**RE:** **Terra Corporate Park, Lot 7 (Scooter's Coffee) SDSP:** Site Development Section Plan, Landscape Plan, Lighting Plan and Amended Architectural Elevations for a drive-up coffee shop located on a 0.84-acre tract of land located west of Trade Center Blvd. and north of Chesterfield Airport Road, zoned "PI" Planned Industrial

RE: City of Chesterfield, MO – Code Comment Response for 16006 Manchester Road (Scooter's Coffee)

The following responses are in regard to the City of Chesterfield, MO Code Comments received on 2/16/22.

**C1.0**  
 SHEET 2 OF 5

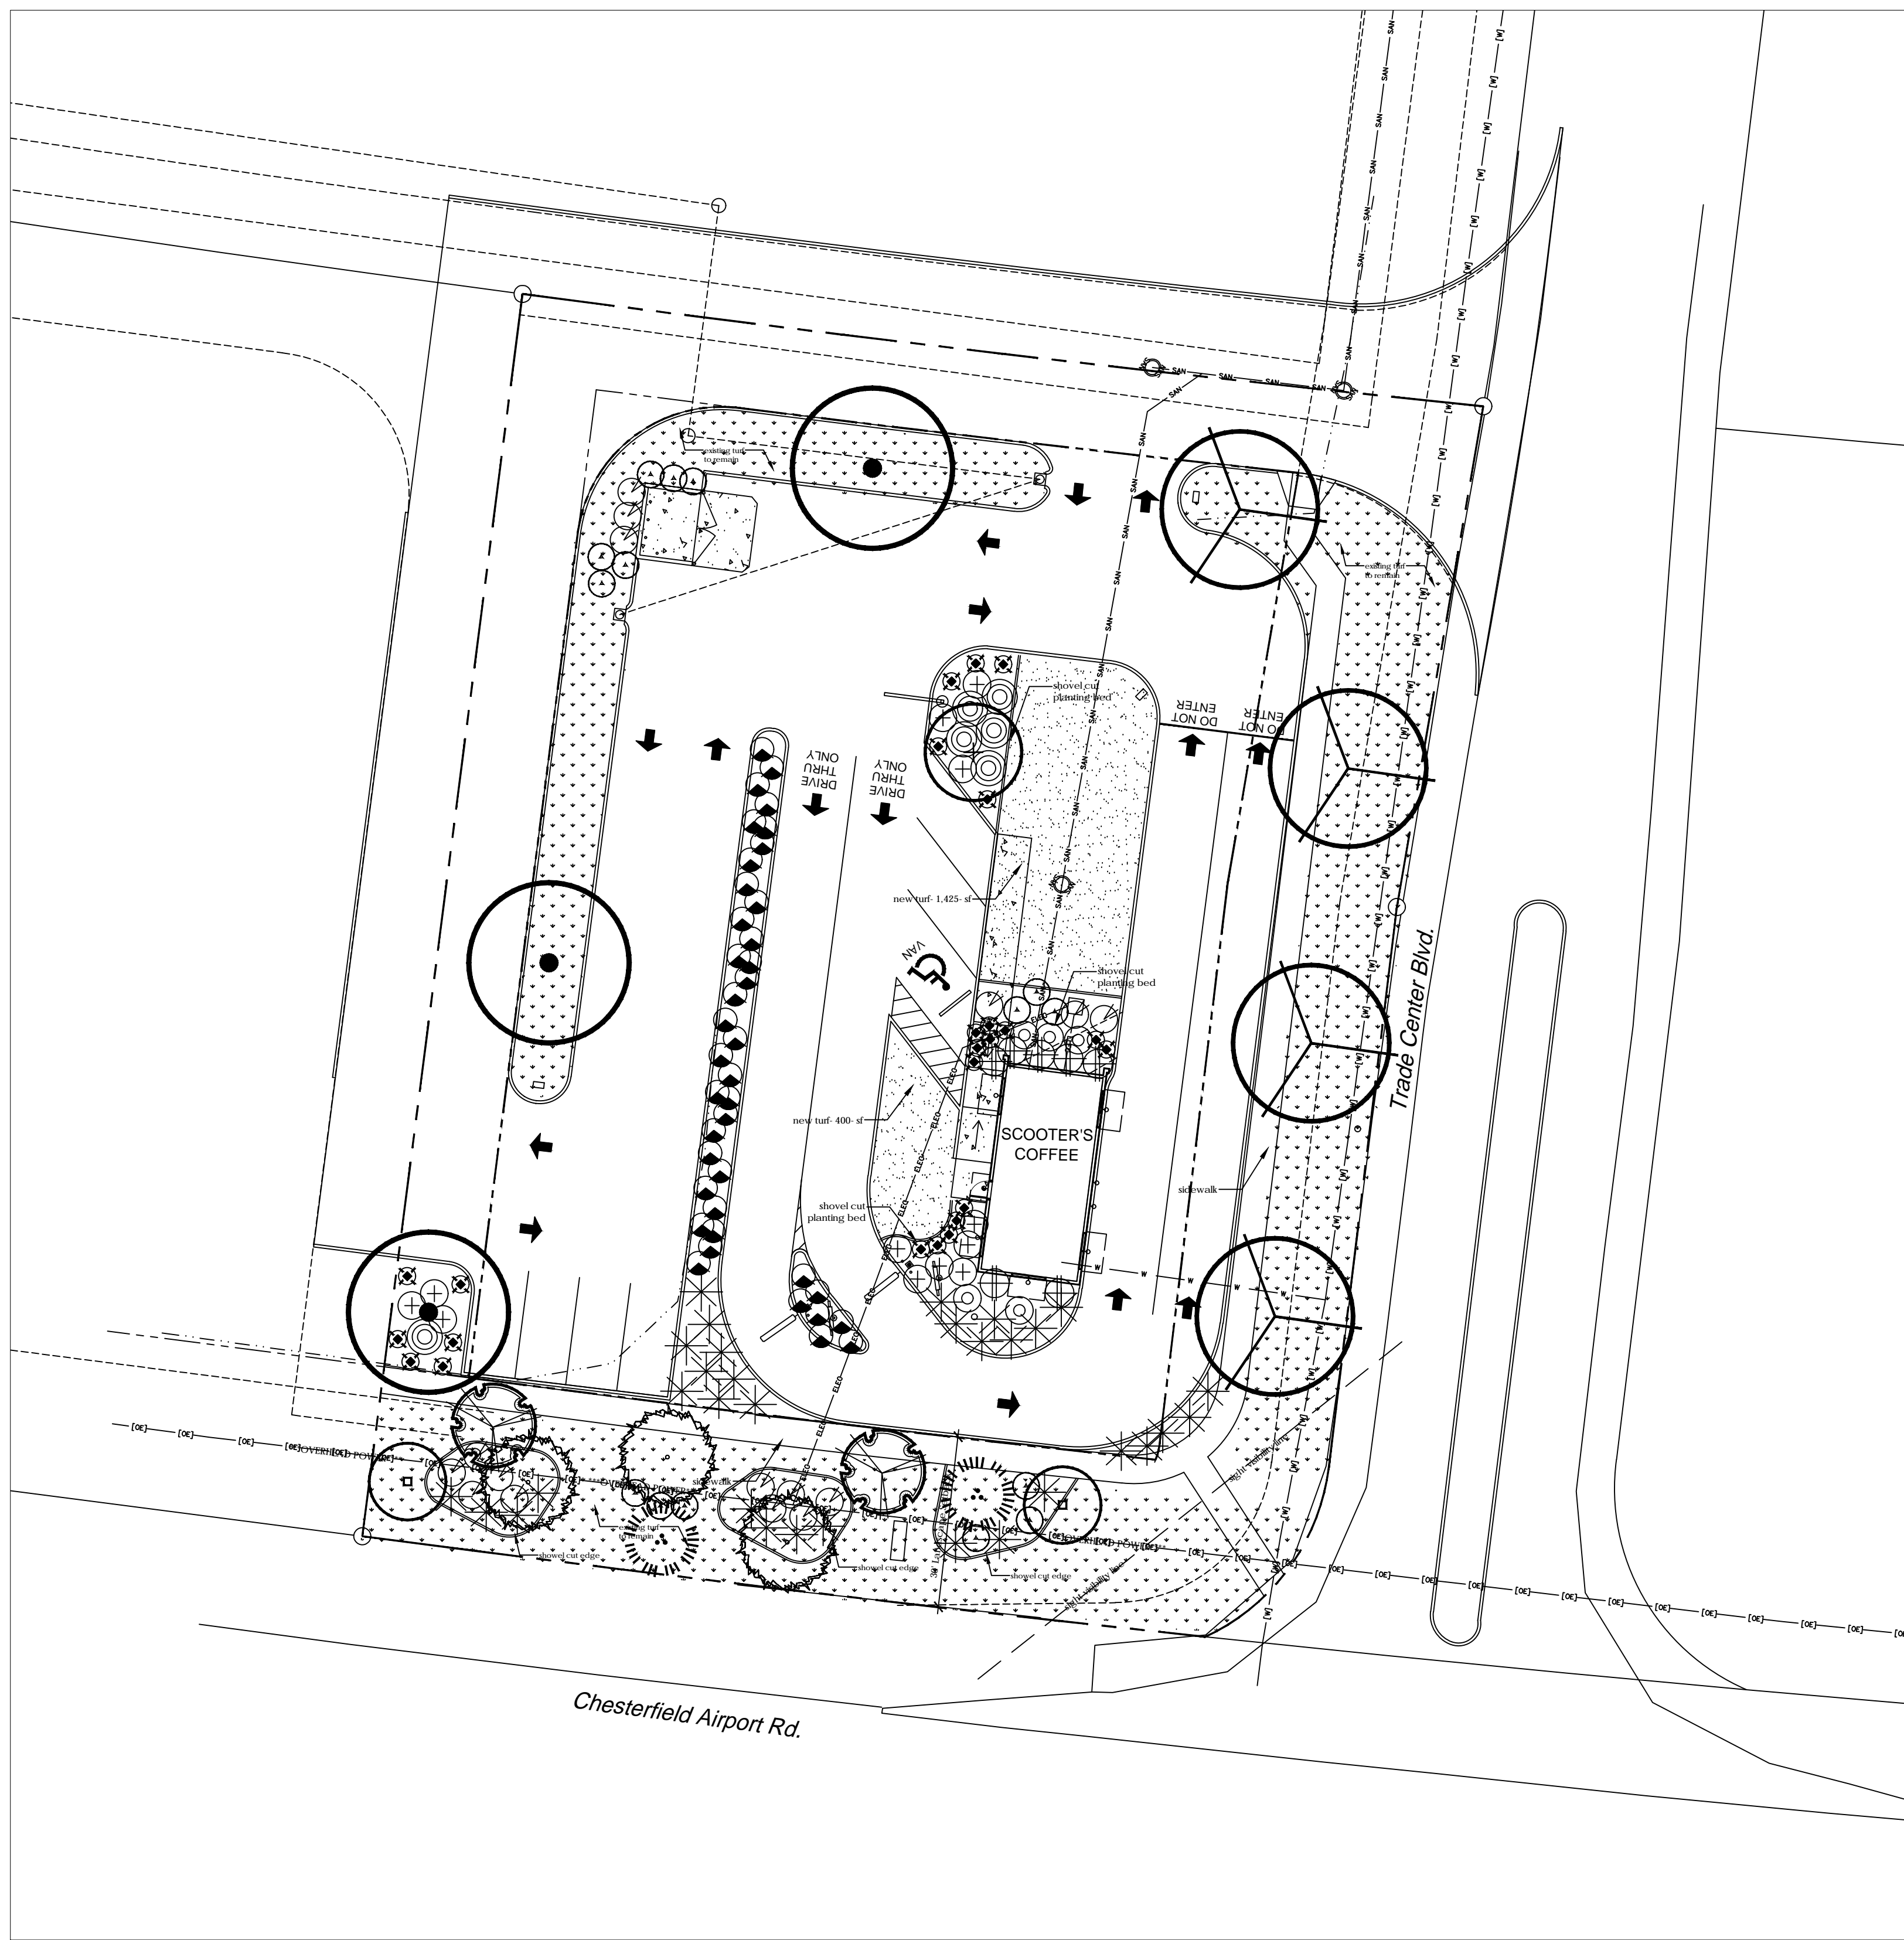
2. **Comment:** Please show the street light location on the site plan.

4. **Comment:** The location of the access points to the internal drives have been revised to match the approved Amended Site Development Concept Plan (ASDCP), as requested in the previous comment letter. However, the plans were not updated to show construction of the associated portions of the north and west internal drives between the access points. Please update the plans to show construction of the internal drives and related improvements north and west of the property to provide internal circulation to the two access points.

5. **Comment:** Provide a street light along the Chesterfield Airport Road frontage.

7. **Comment:** The sidewalk provided at an intersection of Chesterfield Airport Road and N Trade Center Blvd. does not match with the approved Concept Plan of Terra Corporate Park subdivision. The sidewalk layout requires modification to the existing island on North Trade Boulevard for the pedestrians to cross the roadway. Provide a note to indicate that a cross walk will be built through the existing island to provide ADA compliant cross walk for pedestrians as part of this project. Design of the crosswalk will need to be addressed with Improvement Plans.

**Response:** A street light has been added along the Trade Center Blvd frontage. See Sheet C1.0 Proposed Site Plan and the electrical plans.

**Response:** Internal drives between the access points has been show. See Sheet C1.0.

**Response:** See Sheet C1.0 Proposed Site Plan and the electrical plans.

**Response:** The sidewalk has been updated to match the approved Concept Plan of Terra Corporate Park subdivision.

L1.0

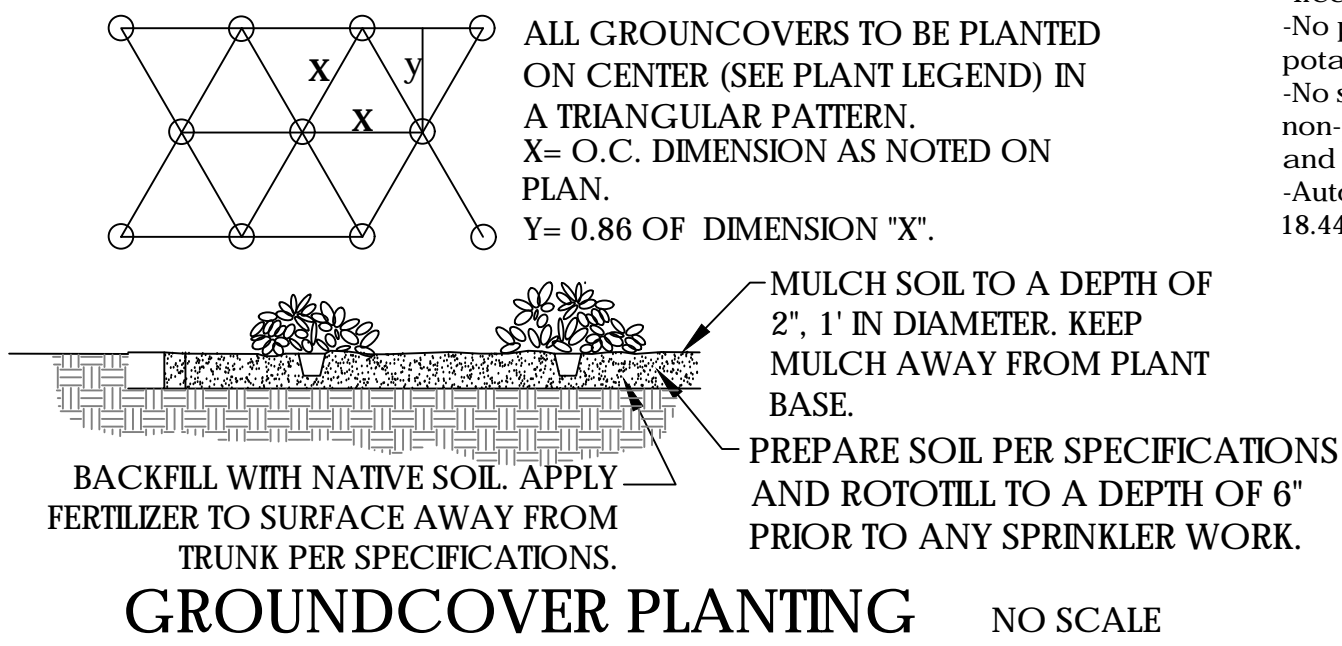
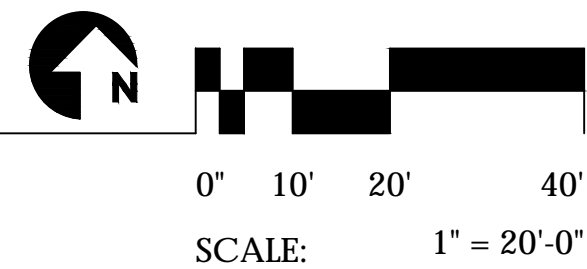
8. **Comment:** Per City code section 405.04.020 Table 2, "30' landscape buffer strip shall be provided on the site facing arterial road", please provide a 30' landscape buffer along Chesterfield Airport Road. Please refer to City Code Section 405.04.020, J for Plant selections. Provide mixture of deciduous trees, evergreen trees, and shrubs.

12. **Comment:** Additional landscaping shall be provided to screen the view of the transformer on the southern boundary.

13. **Comment:** Additional landscaping shall be incorporated around the trash enclosure to properly screen and soften the edge of the site.

15. **Comment:** Further consideration shall be made to remove or relocate the tree (River Birch) at the northwest corner of the building so that it is not too close to the building structure and has room to mature.

**Response:** See Landscape Plan.

**Response:** Additional shrubs were added around the sides of the transformer.

**Response:** Additional 6' tall shrubs were added around the 3 sides of the trash enclosure.

**Response:** The tree adjacent to the building was removed.

**E0.2**

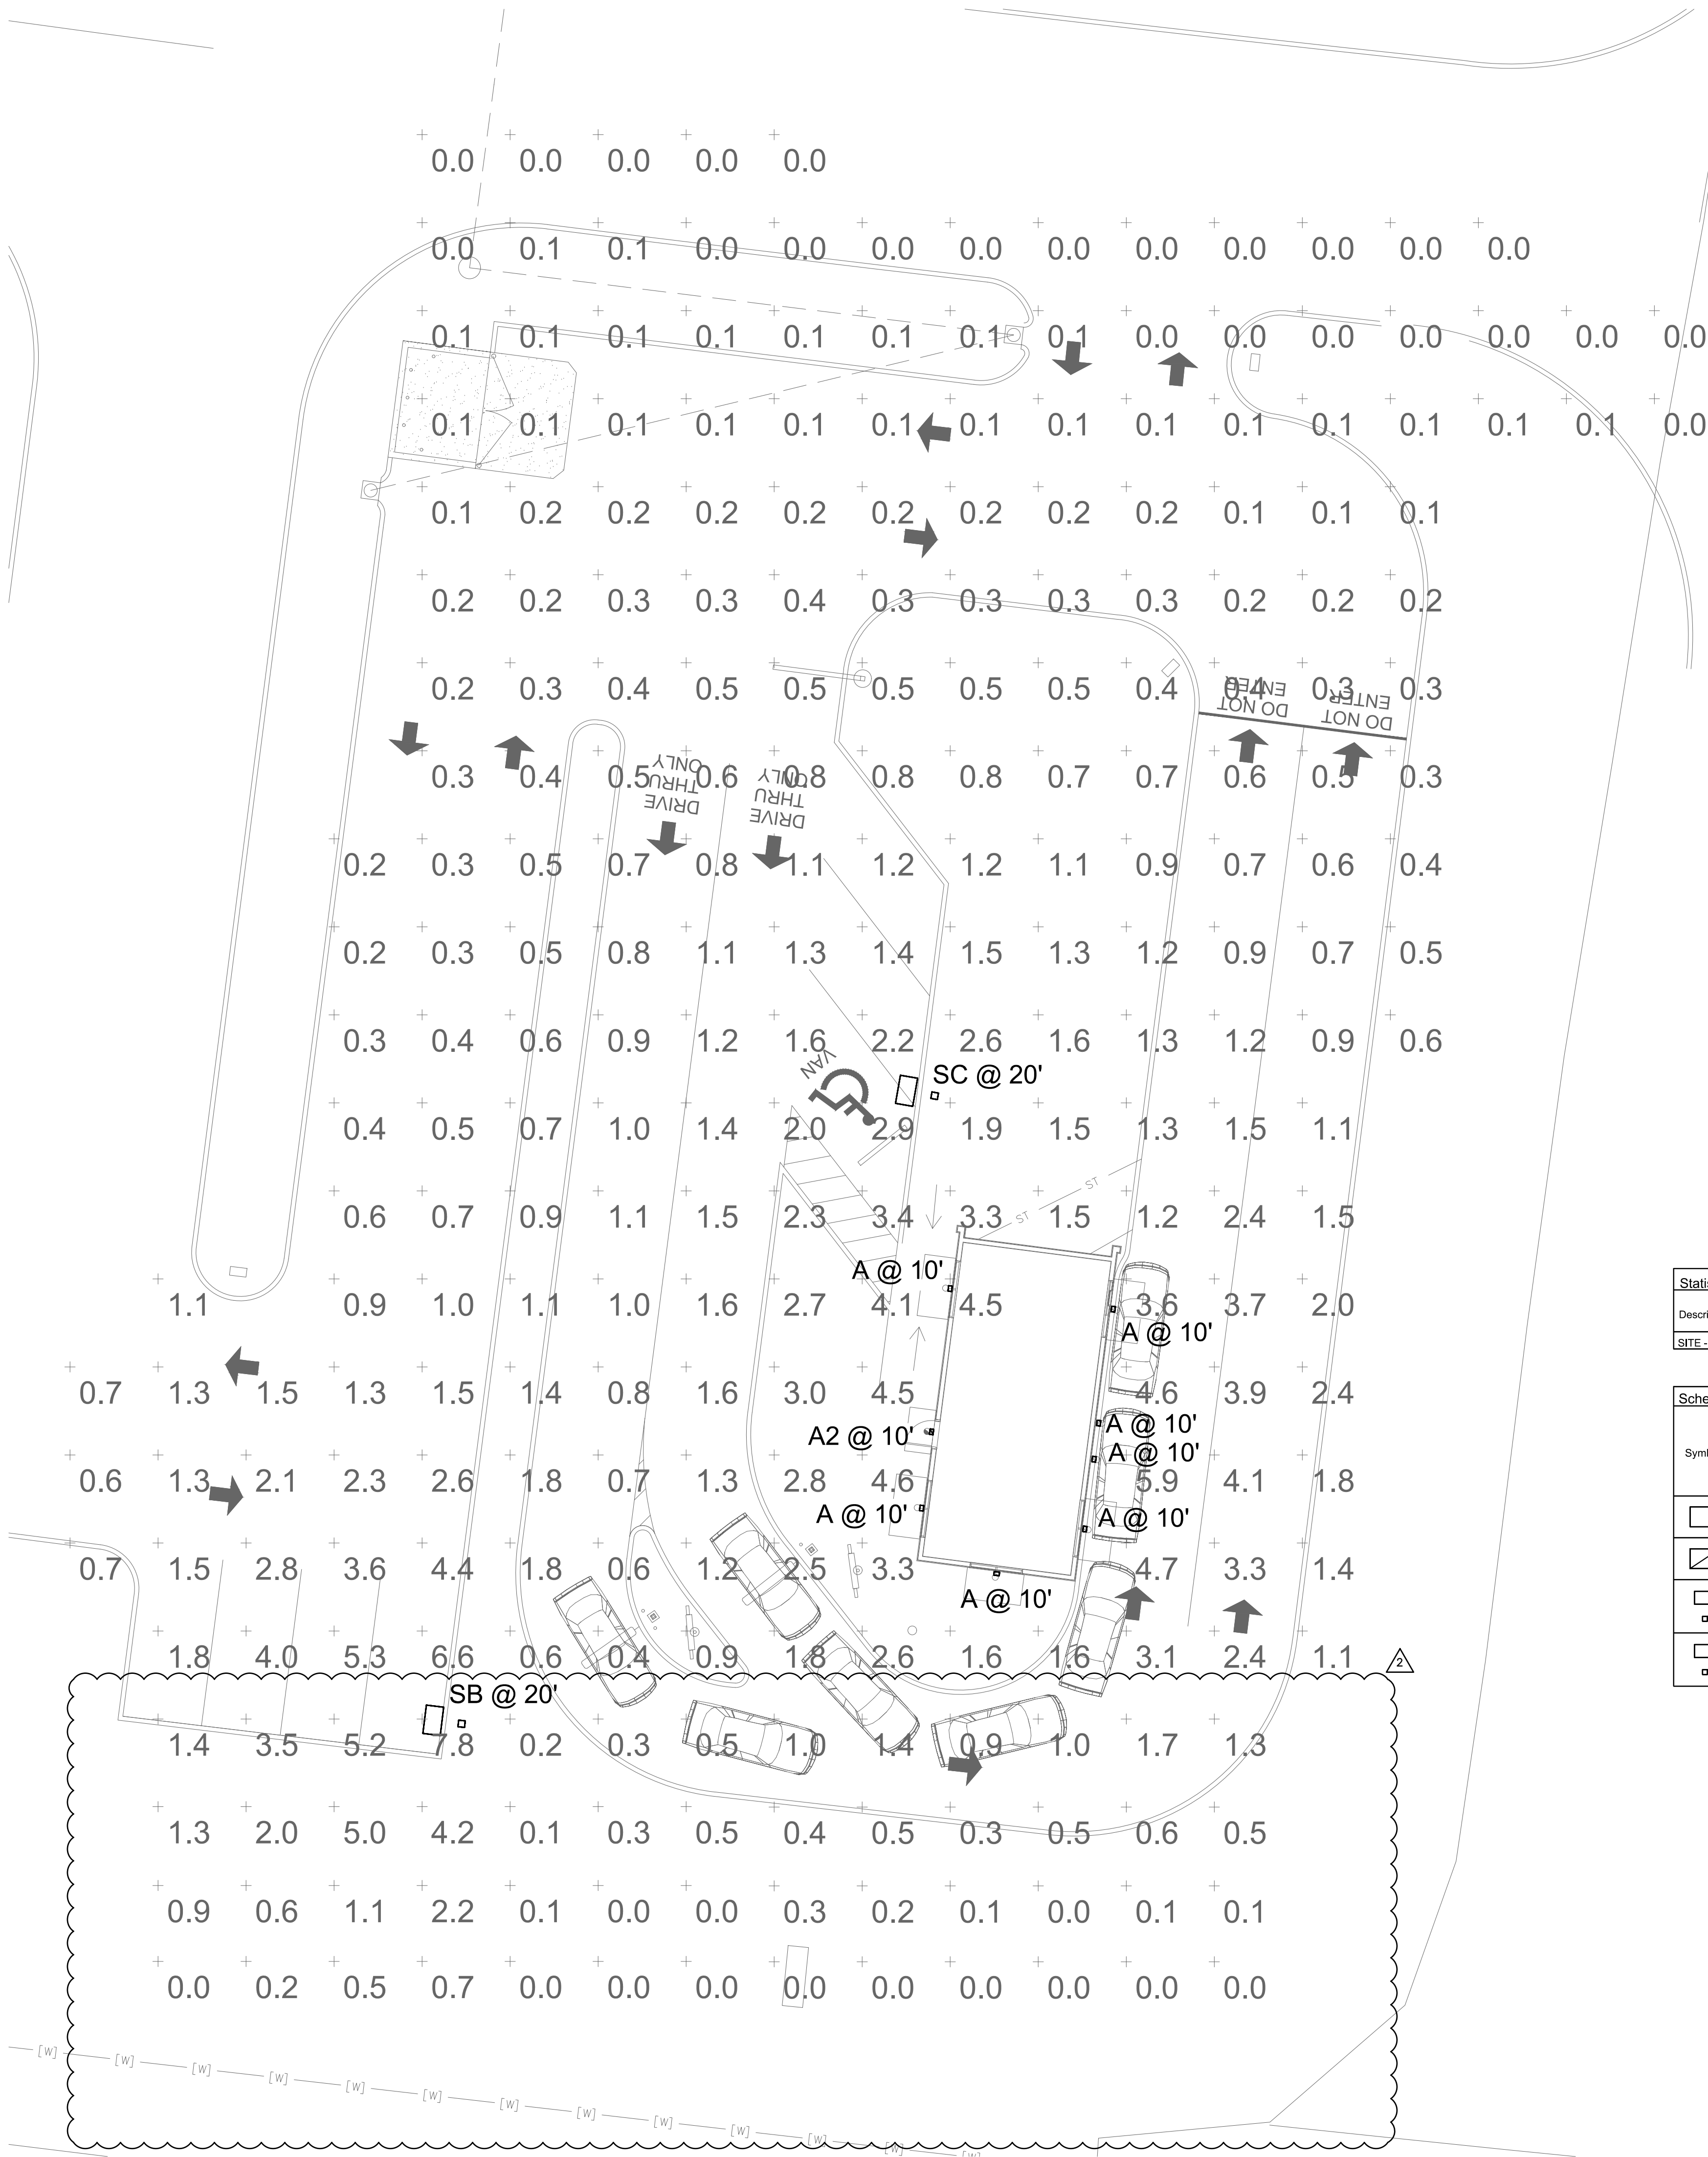
9. **Comment:** The Photometric Plan shows the light level for "SB" as 7.8 fc on the south end of the property, either provide a Photometric Plan showing the light level will be 0.0 fc on the boundary or have a note on the plan that there will be no spill over.

14. **Comment:** The light levels along the southern boundary shall preclude any spillover light on adjacent properties throughout the review of the site plan.

**Response:** See Electrical Plans.

**Response:** See Electrical Plans.
